October 16, 1992
LD-92-108

Docket 52-002

Subject: Combustion Engineering Topical Report CENPD-210-A,
Revision 7

FIGURE 1

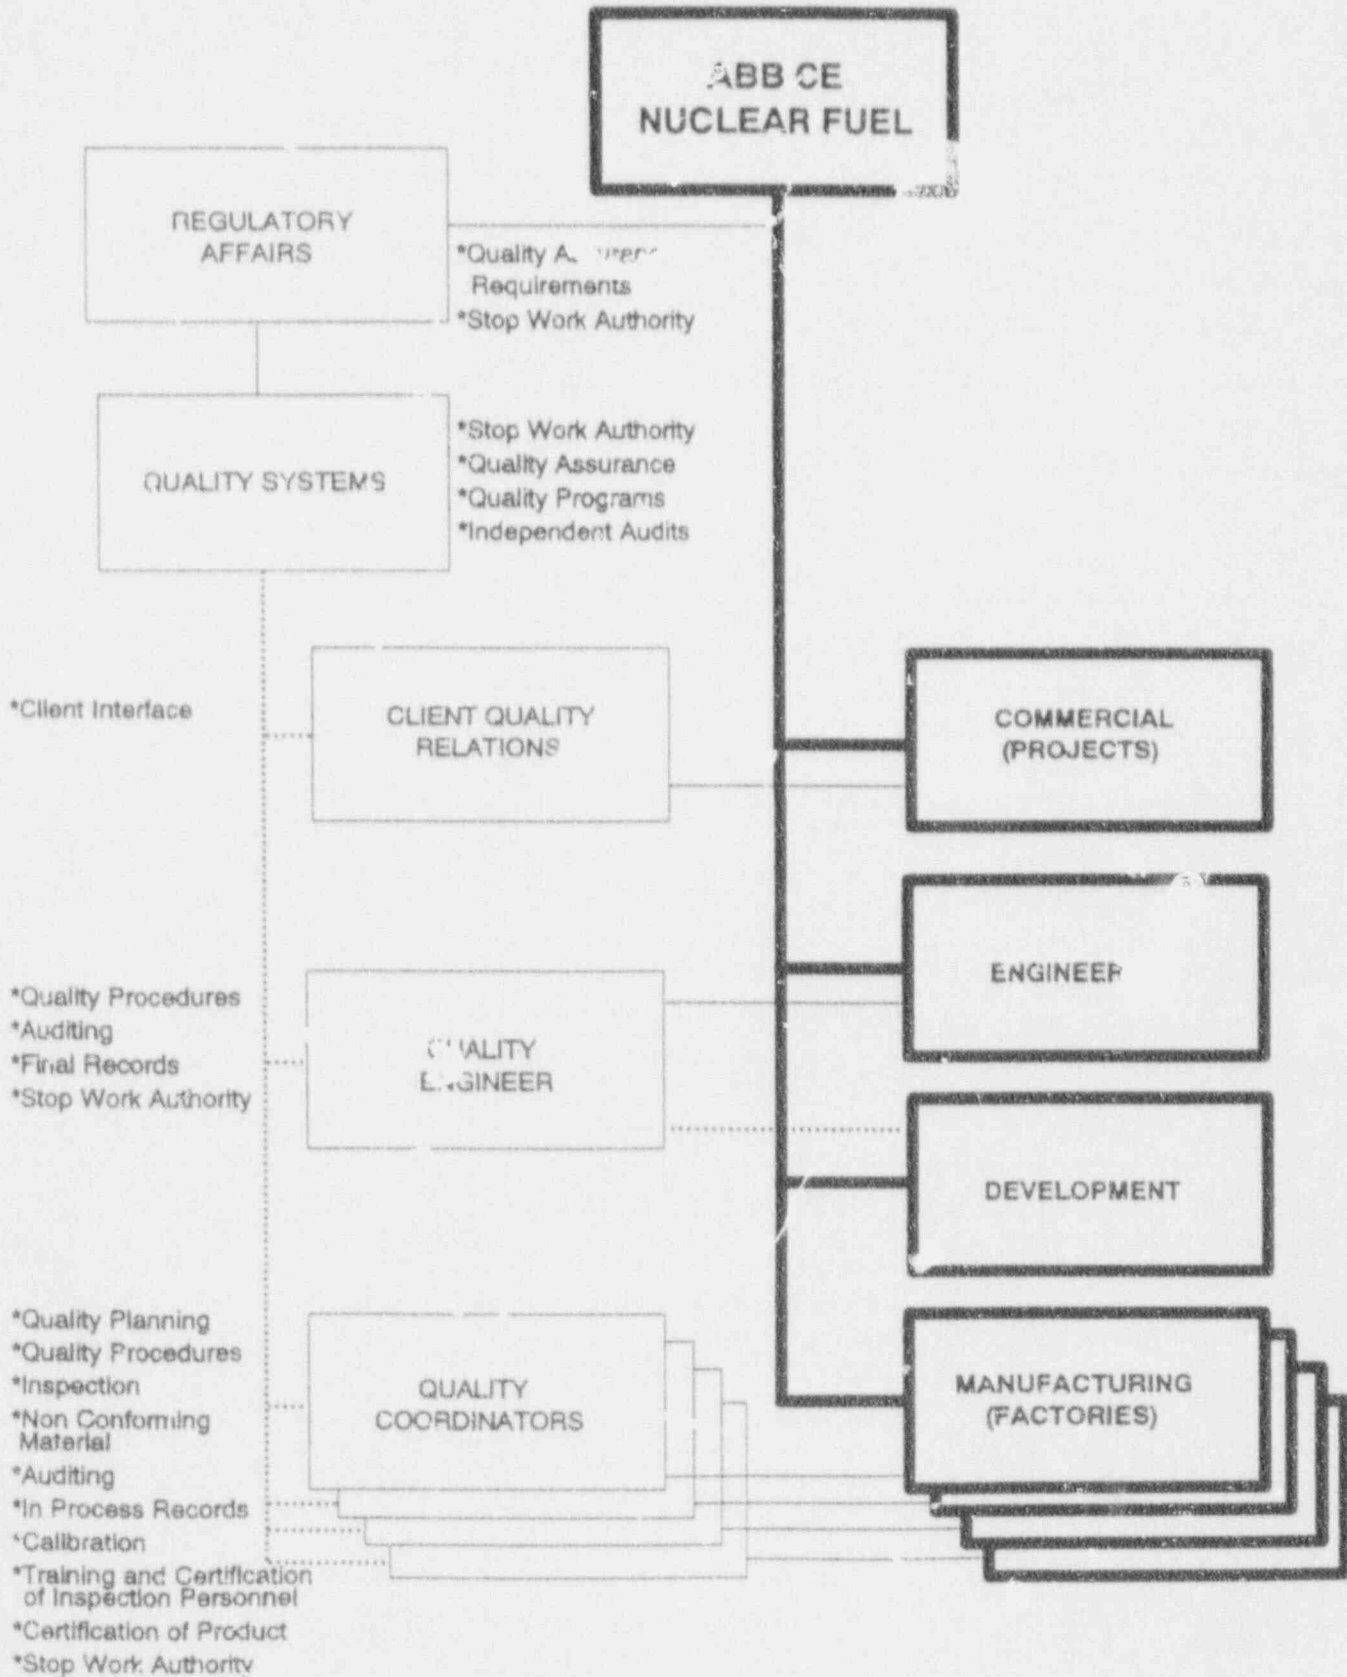
Pursuant to the requirements of Section 1.3 of the subject report and 10CFR50.55 (f)(3), the purpose of this letter is to inform the U.S. Nuclear Regulatory Commission of a change in the quality assurance/quality control alignment of ABB Combustion Engineering Nuclear Fuel. These changes modify the structure shown in Figure II-2 of CENPD-210-A, Revision 7, but do not reduce any of the previously accepted commitments. In fact, all of the individuals and all of the functions have been retained.

Figure 1, attached, outlines the new organization and supersedes Figure II-2 of CENPD-210-A, Revision 7. Again, we emphasize that all of the individuals and all of the functions have been retained in the revised structure.
